**FINDINGS AND RECOMMENDATION  
OFFICE OF PLANNING AND ZONING  
ANNE ARUNDEL COUNTY, MARYLAND**

**APPLICANT:** Microsoft Corporation

**CASE NUMBER:** 2021-0152-V

**REQUEST**

# Roof Access Stairs and Elevator Bulkhead Exceed Zoning Allowable Height

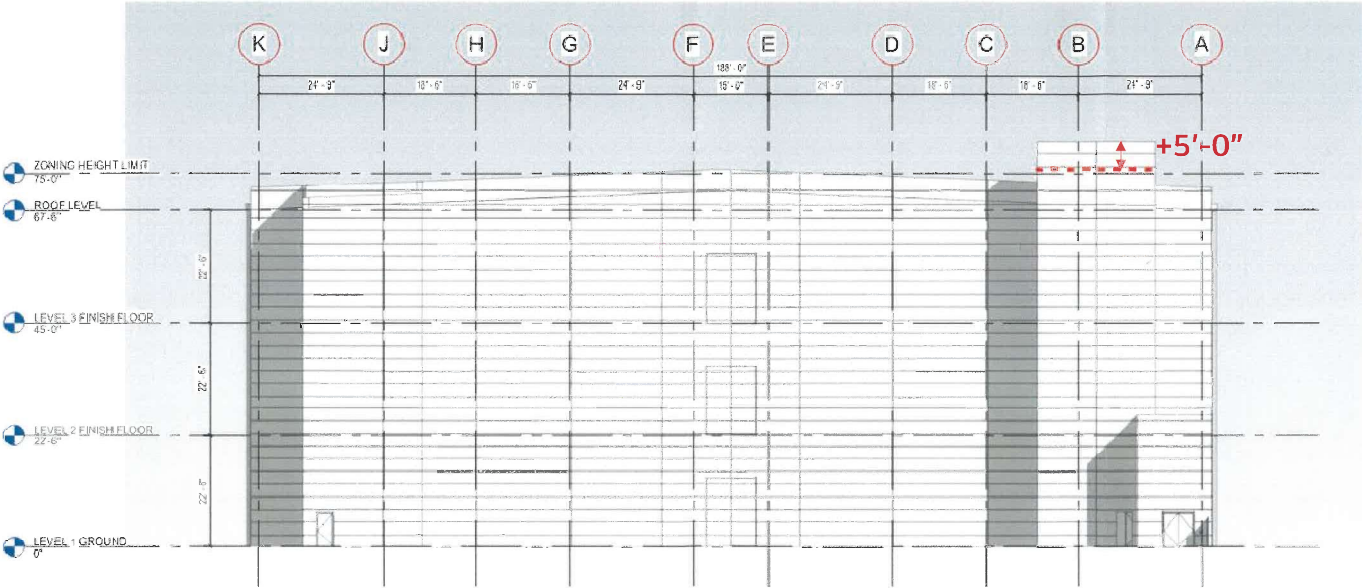
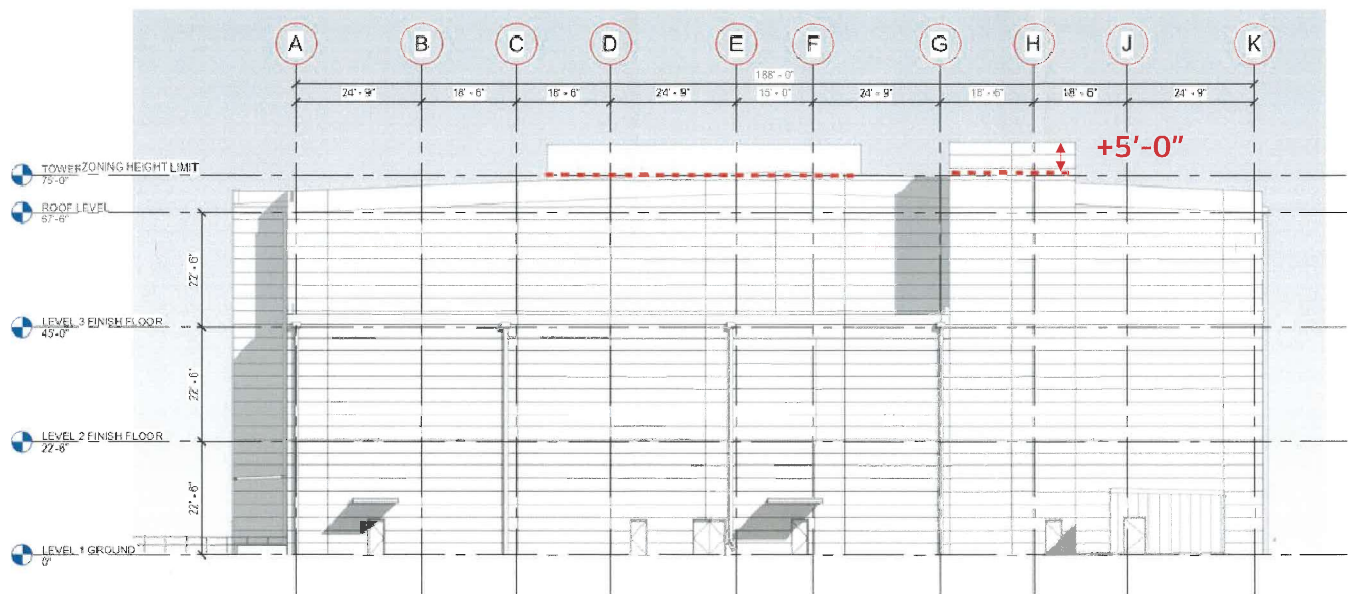
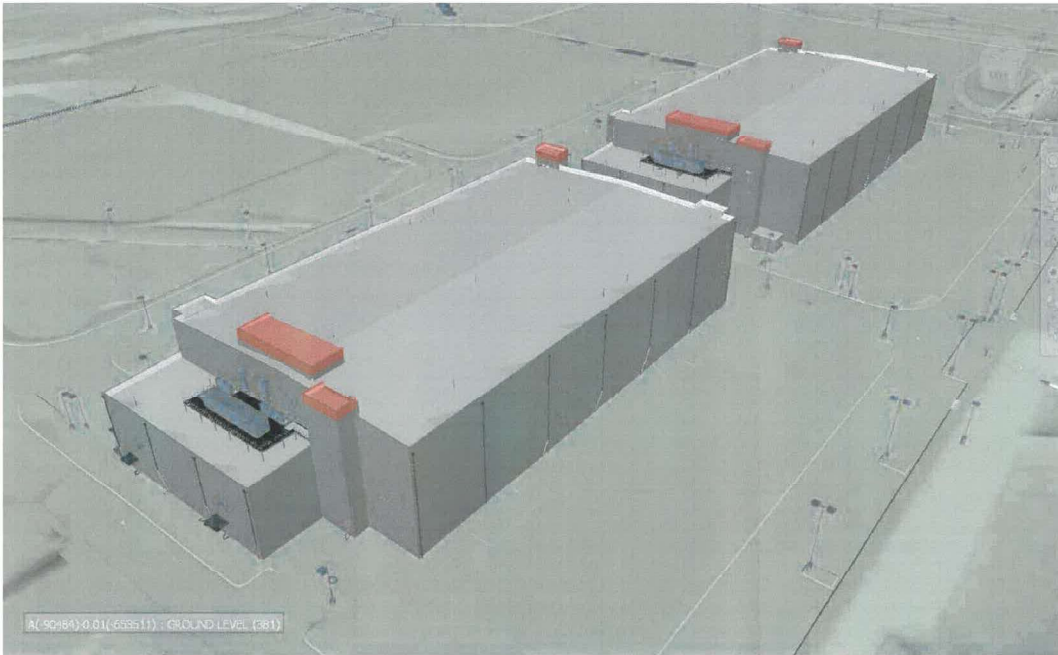
The Code anticipated the need for exceptions to the maximum height limitations for certain rooftop features and provided for specific exceptions in § 18-2-302. The proposed stair towers are not included in the list of exceptions; and, while an elevator bulkhead is included in the list, the proposed bulkhead exceeds the maximum 15% of the cross sectional area of the section of the roof on which it is located. As such, both features are expected to be constructed within the maximum height limitation provided by Code. If the applicant’s specific use requires taller stories than is typical for most commercial buildings, then they should consider designing a building with a larger footprint and only two stories high in order to accommodate their desired use within

Two Roof Access Stairs, and the Elevator Machine Room Bulkhead comprise 2 ½ % of the overall building footprint. The upper 5'-0" of each are **highlighted in red**, as that portion of each exceeds the allowable building height defined in the Zoning Code.

While the proposed variance to allow the accessory structures to be located in the front yard are justified, the proposed height variance is not warranted and cannot be considered the minimum necessary to afford relief.

Based upon the standards set forth in § 18-16-305 of the Code under which a variance may be granted, this Office recommends ***approval*** of a zoning variance to § 18-2-204(b) to allow accessory structures in the front yard of a nonwaterfront lot as shown on the site plan provided by the applicant. However, this Office recommends ***denial*** of the proposed zoning variance to § 18-6-301 to allow a proposed commercial structure with greater height than allowed.
